**Los Angeles Unified School District
Office of the Inspector General**

Technical Evaluation

**Pinner Construction Co., Inc.
and the Taft Charter High
School Plumbing Utilities
Project**

**24-440-TE
May 19, 2025**

**Figure 26. Construction Documents Sheet C-4.2 (Site Utility Plan) Excerpt
Cannon Design - April 1, 2020**

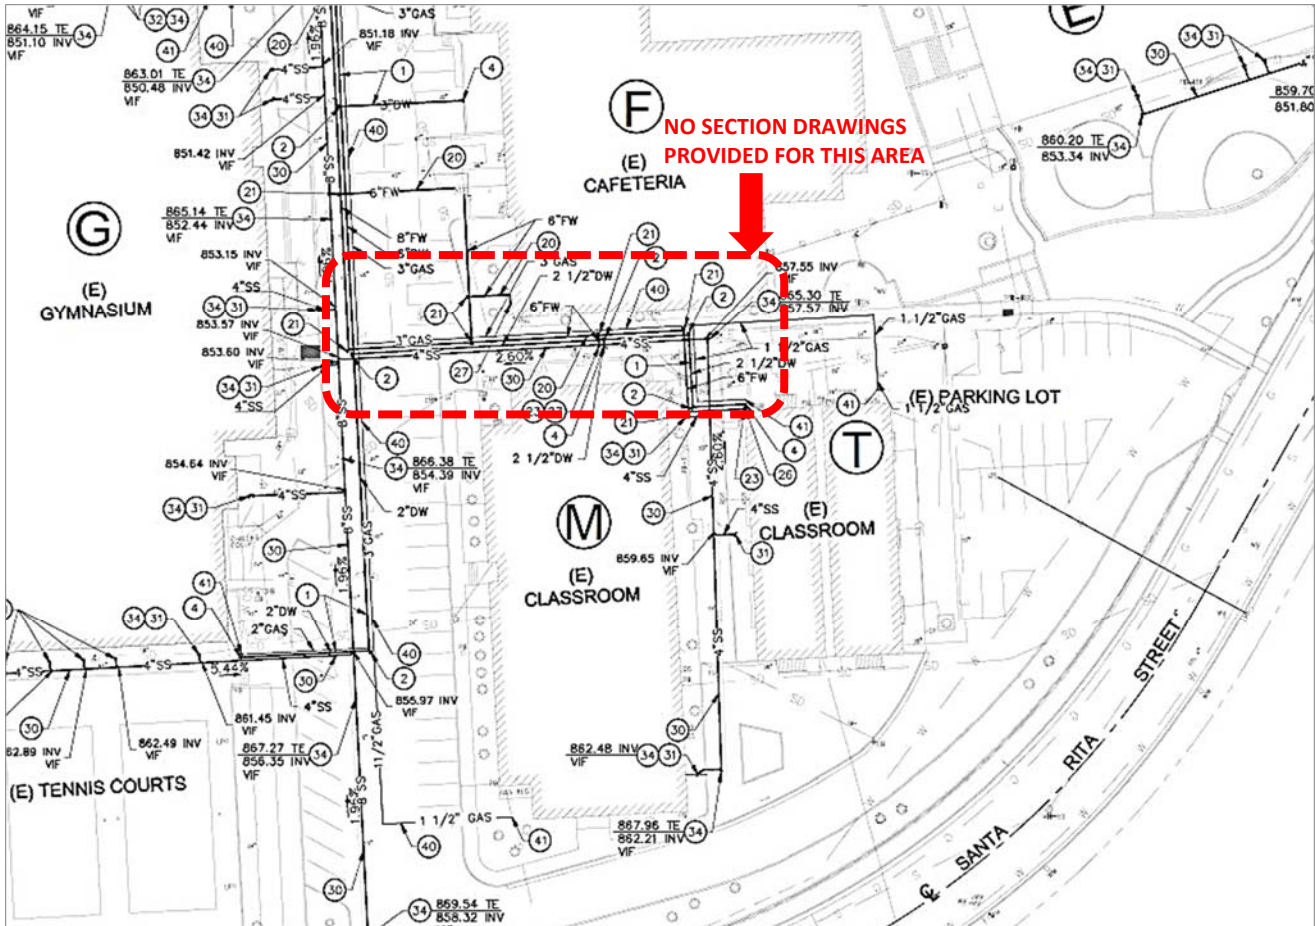
The resolution of this issue was affected by design deficiencies in the design and construction documentation, which did not account for adjacent building site conditions. Ideally, the commissioned architecture and design should have drawn a site section showing the adjacent building profiles. Only basic plan information was provided (Figure 26).
